## Commission of Architectural Review

5. COA- 142784-2024	<b>Final Review</b>	Meeting Date: 2/27/2024
Applicant/Petitioner	Rodney Young	
Project Description	Replace a steel fire escape with wood.	
Project Location		
Address: 22 South Arthur Ashe Boulevard		
Historic District: Boulevard		
High-Level Details: <ul style="list-style-type: none"> <li>The applicant proposes to fully remove and replace the south fire escape and the exterior stairs located on the north side of the building.</li> <li>The fire escape on the south side of this building is highly visible, along the north side of West Cary Street.</li> <li>The central stairs, along the north side of the building are not visible from public right of ways.</li> <li>This building is a 4-story multi-family apartment building, built in 1921.</li> </ul>		
Staff Recommendation	Partial Approval	
Staff Contact	Annie Delaroderie, <a href="mailto:anne.delaroderie@rva.gov">anne.delaroderie@rva.gov</a> , 804-646-6335.

Figure 5. Zoomed-in image of deterioration of the steel and concrete floors along the second floor of the fire escape.

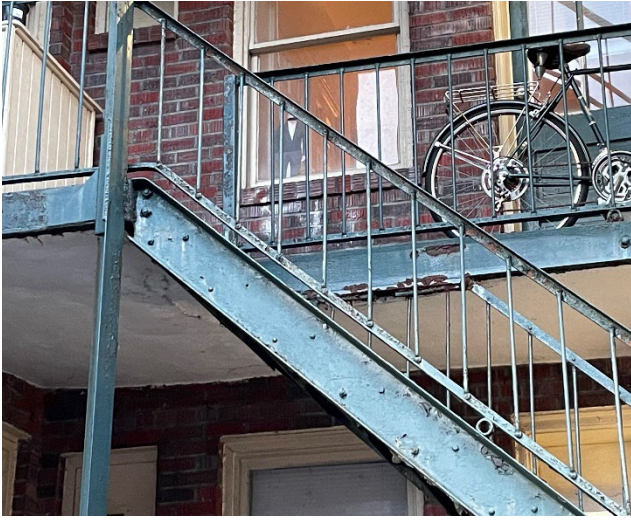
Previous Reviews	None	
Conditions for Approval	<p>Staff recommends <i>denial</i> of:</p> <ul style="list-style-type: none"> <li>The replacement of the fire escape's steel framing, stairs, and concrete floor with wood.</li> </ul> <p>Staff recommends <i>approval</i> of:</p> <ul style="list-style-type: none"> <li>The replacement of the fire escape's steel framing, stairs, and concrete floor with in-kind materials, if the existing materials are beyond repair.</li> </ul>

Construction, page 59.	<i>limited to wood siding, shingles, stucco, and masonry.</i>	Staff was unable to determine if these are the original fire escapes but believes they are original or they have gained significance overtime.
Standards For Rehabilitation: Residential Construction, page 59.	<i>3. Retain original metal features such as cast iron porches and steps, metal cornices, roofs, roof cresting, window sash, entablatures, columns, capitals, window hoods, and hardware and the color and finish of all original materials.</i>	<p>The steel framing systems are likely the original material and create a character-defining element. Installing wooden staircases, railings, and framing in this location would change the visual appearance of this building and is not compatible.</p> <p><u>Staff recommends denial of the replacement of the fire escape's steel framing, stairs, and concrete floor with wood.</u></p> <p><u>If the fire escapes steel and concrete elements are deteriorated beyond repair, staff recommends that these materials should be replaced in-kind.</u></p>

Standards For Rehabilitation: Residential Construction, page 59.	<i>7. Repair damaged elements instead of replacing them. Use materials that match the original in type, or use physically and chemically compatible substitute materials that convey the same appearance as the surviving elements or sections.</i>	<p>If the steel is in poor condition and cannot be repaired <u>staff recommends replacing the fire escape with in-kind materials.</u> The fire escape is a significant historic feature of this building, and steel or a similar material would be more compatible.</p>
